* * * FACSIMILE MESSAGE * * *

RE: DIFFUSION CALCS
LIGO QUALIFICATION TEST
FACILITY
930212 File #2.2.2

DIFFUSION CHARACTERISTICS.
440° BAKE

DIFFUSION CURVES

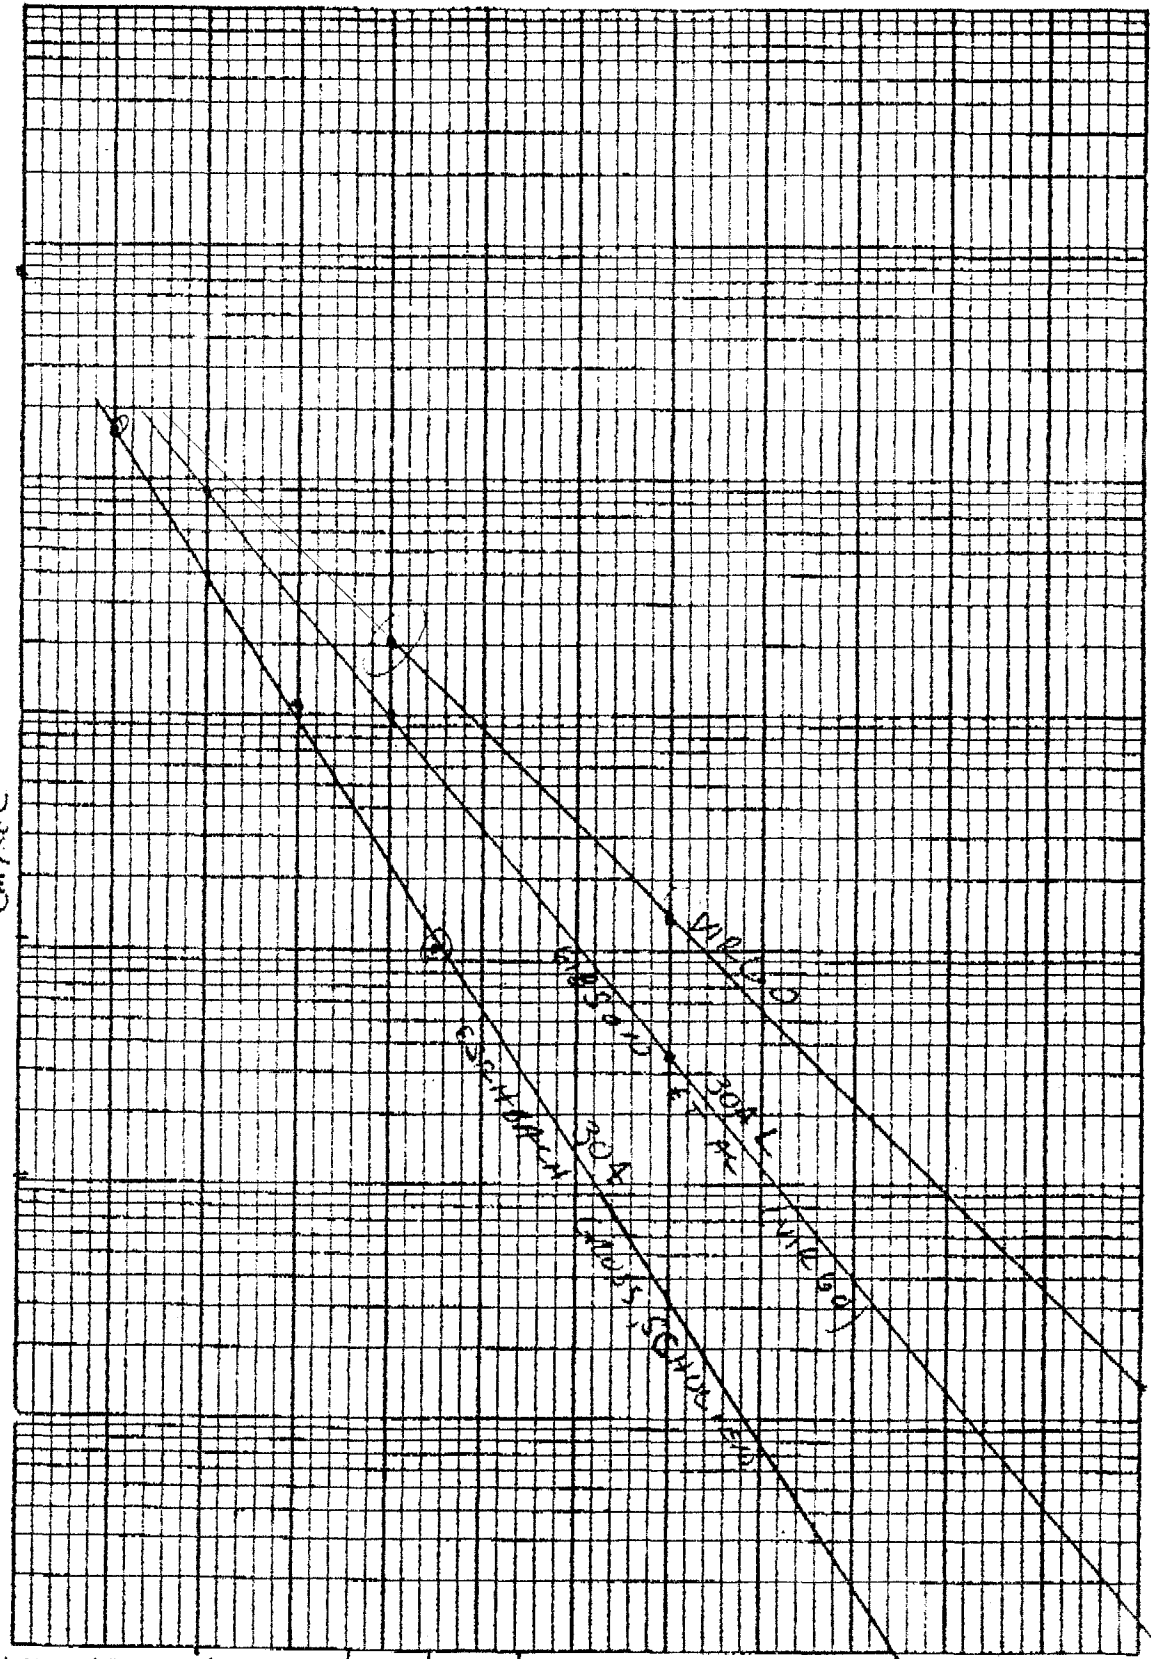
Also please note that I have shown Eschbachs diffusion curve along with two curves shown in the Virgo paper. Why do you think Calder and Lewin is more correct?
